Proposal #09: 2035-06-70, WISC 2017 267
Watertown Plank Rd, City of Wauwatosa
Underwood Creek Strs B-40-0470/0471
Local Street
Milwaukee County

This is Addendum No. 01, which provides for the following:

ADDENDUM NO. 01

Addendum No. 01
 ID 2035-06-70
 Revised Sheet 25
 April 20, 2017

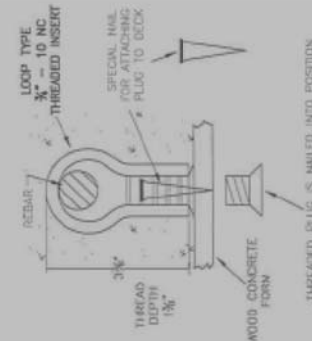
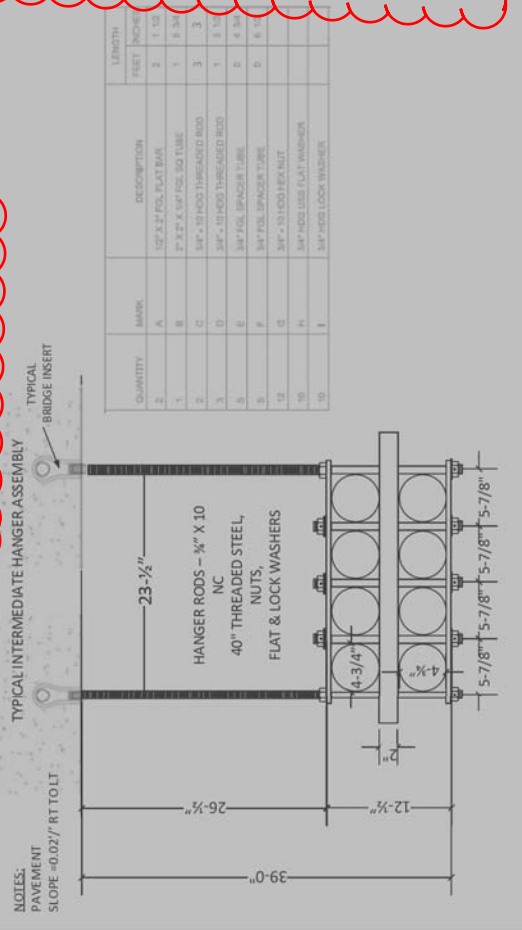
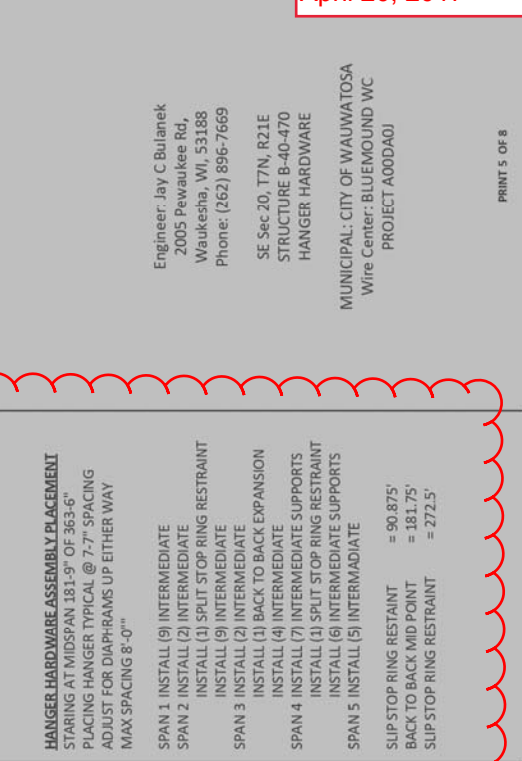
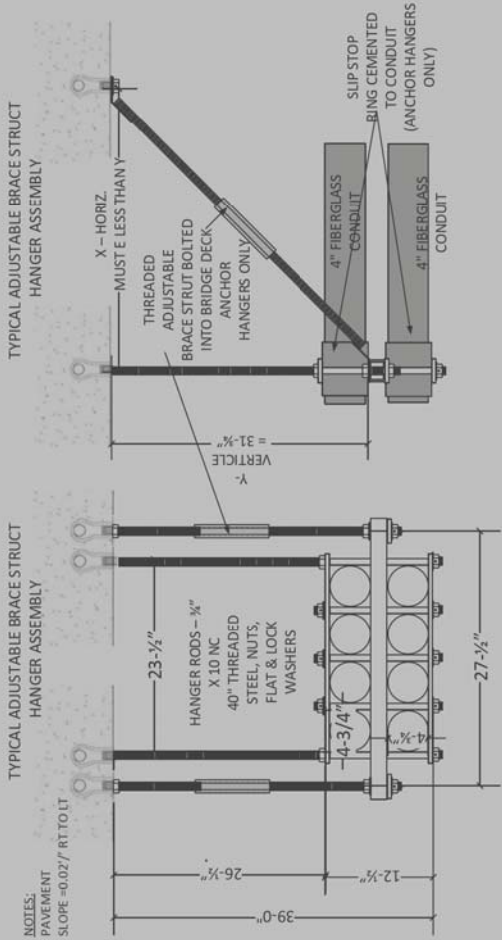
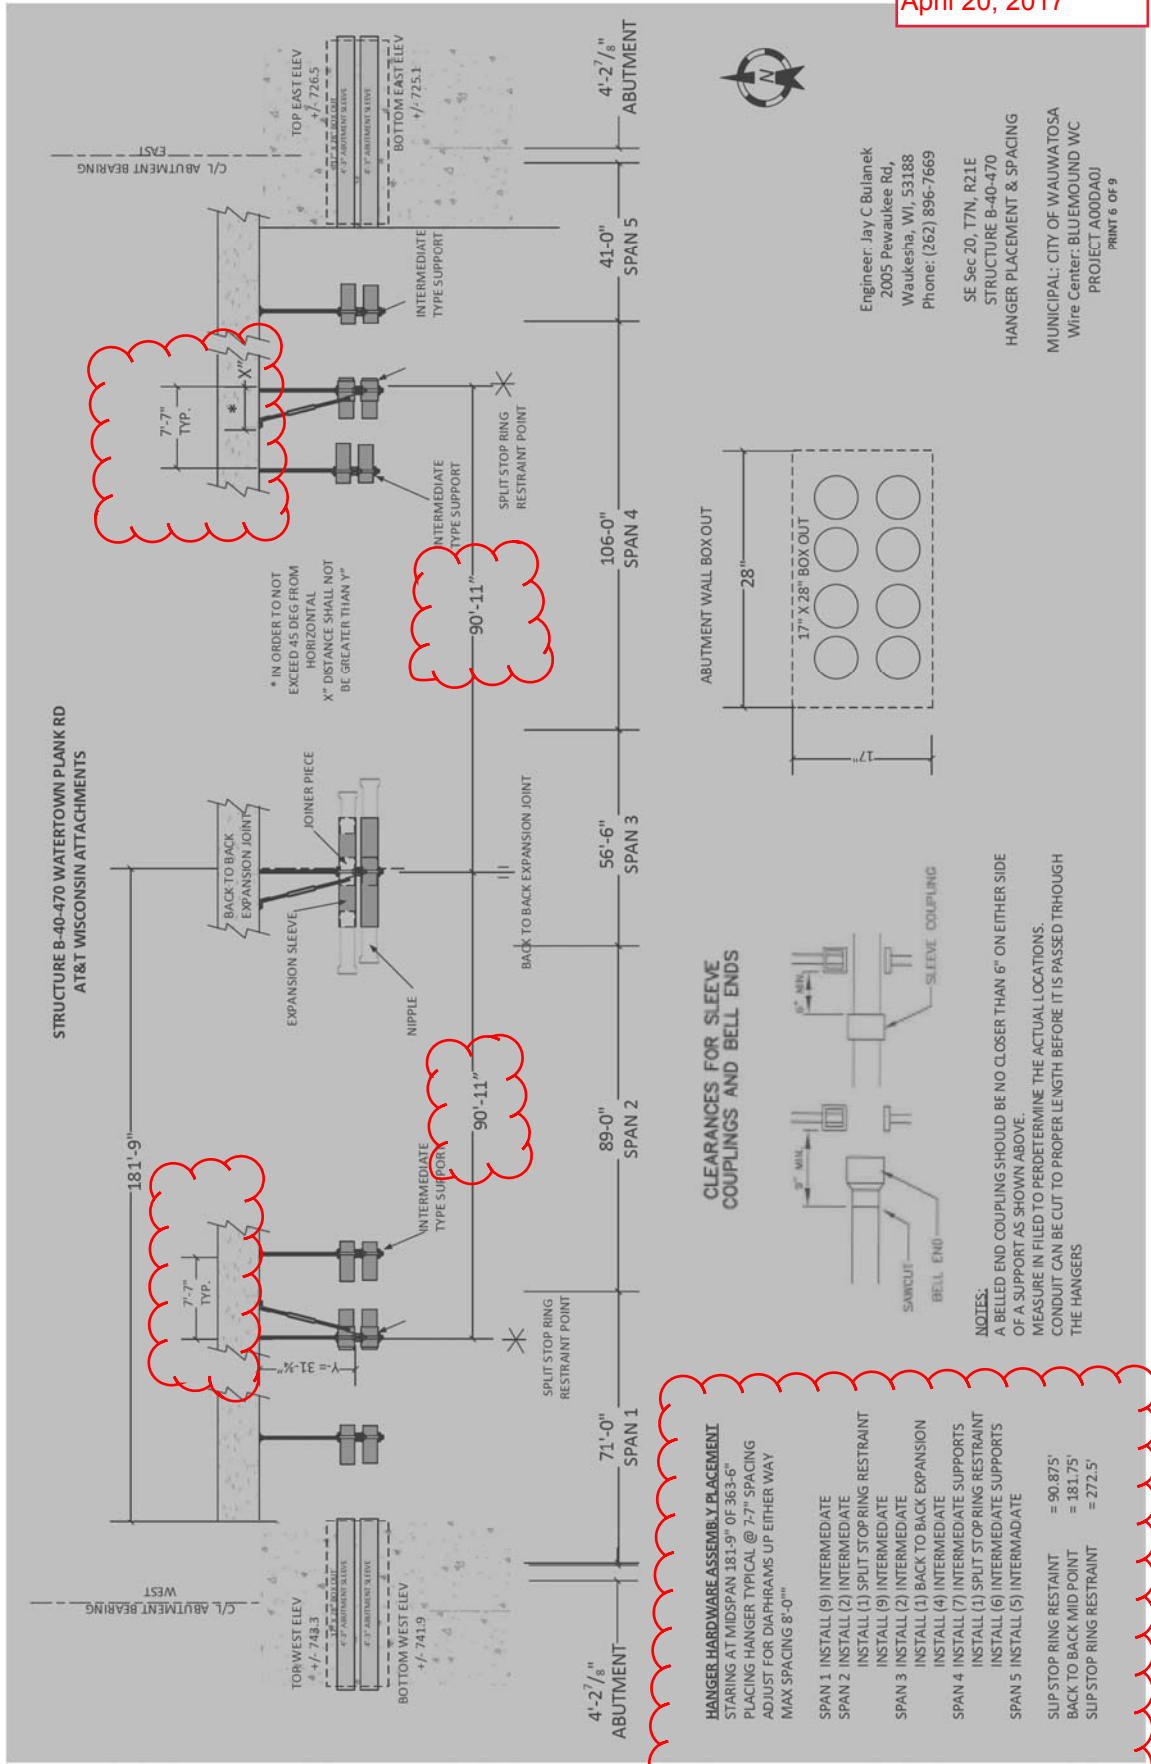
Revised Plan Sheets	
Plan Sheet	Plan Sheet Title (brief description of changes to sheet)
25	Construction Detail AT&T B-40-0470 Attachment - Revised to show decreased eyelet (insert) spacing for AT&T facility.
26	Construction Detail AT&T B-40-0470 Attachment – Revised to show decreased eyelet (insert) spacing for AT&T facility.
27	Construction Detail AT&T B-40-0470 Attachment – Revised to show decreased eyelet (insert) spacing for AT&T facility.
49	Permanent Signing and Marking – Revised to show pavement marking replacement extension limits on eastbound lanes.
131	Miscellaneous Quantities – Revised to show added bid item 647.0166 Pavement Marking Arrows Epoxy Type 2 and additional pavement marking quantities related to the pavement marking replacement extension limits on eastbound lanes
134	Miscellaneous Quantities – Revised to show added bid item 647.0955 Removing Pavement Markings Arrows and additional pavement marking removal quantities related to the pavement marking replacement extension limits on eastbound lanes.

During re-decking, the WisDOT contractor shall install the eyelets (inserts) for the proposed hanger assemblies, as shown in the construction details. The eyelets (inserts) shall be installed from mid-deck out at intervals of 7'-7" spacing (typical) throughout the length of the bridge (Note: 3 locations require additional inserts for brace struts as shown in Construction Details "AT&T B-40-0470 Attachment").

There are (47) intermediate hanger assemblies to be installed (inserts at 7'-7" intervals); and (3) brace strut(s) inserts to be installed for (1) back to back expansion joint assembly at mid-point of deck 181'-9" from front face of back-wall and at the (2) Stop Split Ring Assemblies at 90'-11" from mid-point east and west (see Construction Details "AT&T B-40-0470 Attachment").
